Bang & Olufsen

Beomaster 7000

Beomaster 6500

Corrections

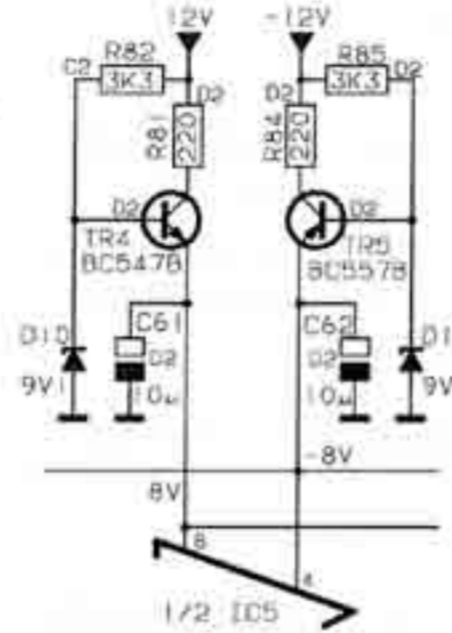
An kondensator part no. 4200510 10μ 20% 16V has been added to the collector on 2TR16.

3R81 and 3R84 5010092 220Ω 5% 1/4W has been added:

7TR2 BC338 is an NPN transistor. Emitter to the ground.
